# United States Patent and Trademark Office

APPLICATION NO.	F	ILING DATE	FIRST NAMED INVENTOR	ATTORNEY DOCKET NO.	CONFIRMATION NO.
10/631,817		08/01/2003	Pao-Hsien Cheng	MR957-1368 1719	
4586	7590	12/16/2004		EXAM	INER
ROSENBE			KLEBE, GERALD B		
3458 ELLIC ELLICOTT		NTER DRIVE-SUITE D 21043	101	ART UNIT	PAPER NUMBER
	,			3618

Continuation of Attachment(s) 6). Other: examiner's mark-up of prior art figures(2 sheets).

Attachments: Examiner's mark-up of Figs 1 and 2 of US Patent 5421604 (2 sheets)

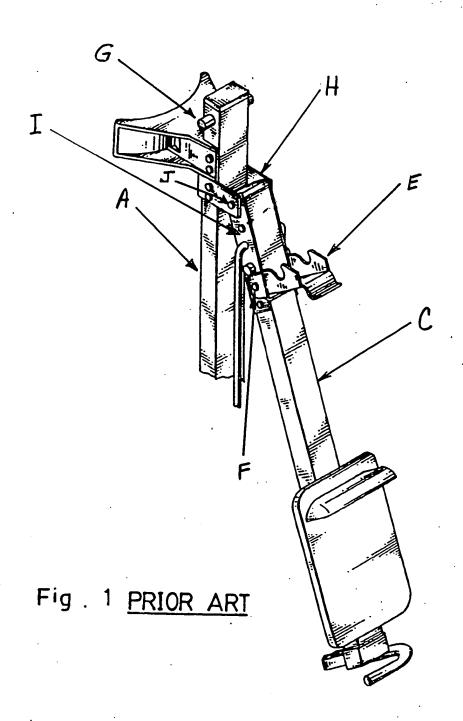
Wu teaches as old and well-known (refer Figs 1-3, and the examiner's mark-up of copies of these figures provided in explanation that are attached hereto) a foldable golf bag cart comprising:

a main support member (refer examiner's mark-up of Figs 1 and 2, item A) having two wheeled supports (B) pivotally coupled thereto;

a handle rod (C) pivotally coupled to an upper end of the main support member at a lower end thereof;

two co-moving rods (D) pivotally coupled to the handle rod at upper ends of the two co-moving rods, and pivotally coupled to respective ones of the wheeled supports (B) at lower ends of the two co-moving rods, the handle rod (C) having a fixing hook (E) pivotally coupled thereto by means of a pivotal element (F), the main support member having an engaging protrusion (G) thereon, the fixing hook being engageable with the engaging protrusion to prevent the handle rod from moving relative to the main support member when the golf bag cart is in a stretched position (shown in Fig 2),

the handle rod (C) having a through hole, and the fixing hook having a through hole, the pivotal element (F) being passed through the through holes of the handle rod and the fixing hook; and,

(re: claim 2) wherein the main support member has a plurality of connecting ears (H) with opposing pivotal hole formed therein, and the handle rod has a plurality of connecting ears (I) with opposing pivotal holes formed therein and a pivotal rod (J) passed through the opposing pivotal holes of the connecting ears of the main support member and the opposing pivotal holes of the connecting ears of the handle rod.

Wu is silent as to the pivotal element being a rod threaded on an end and threaded into a nut to make the connections.

Fig . 2 PRIOR ART

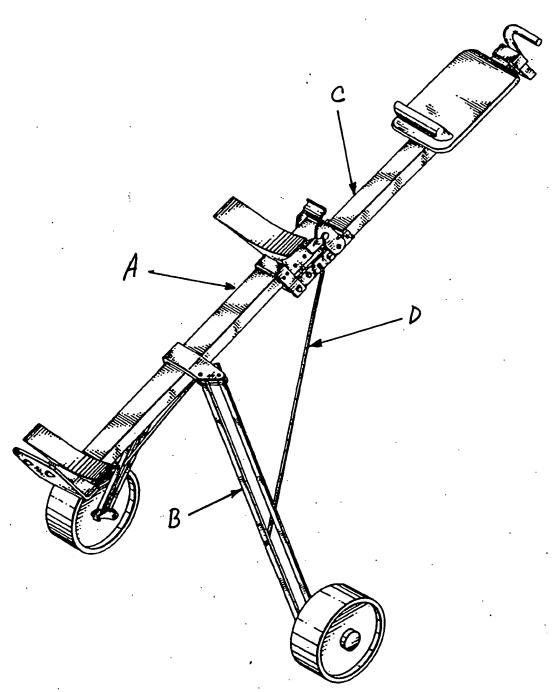
prevent the handle rod from moving relative to the main support member when the golf bag cart is in a stretched position (shown in Fig 2).
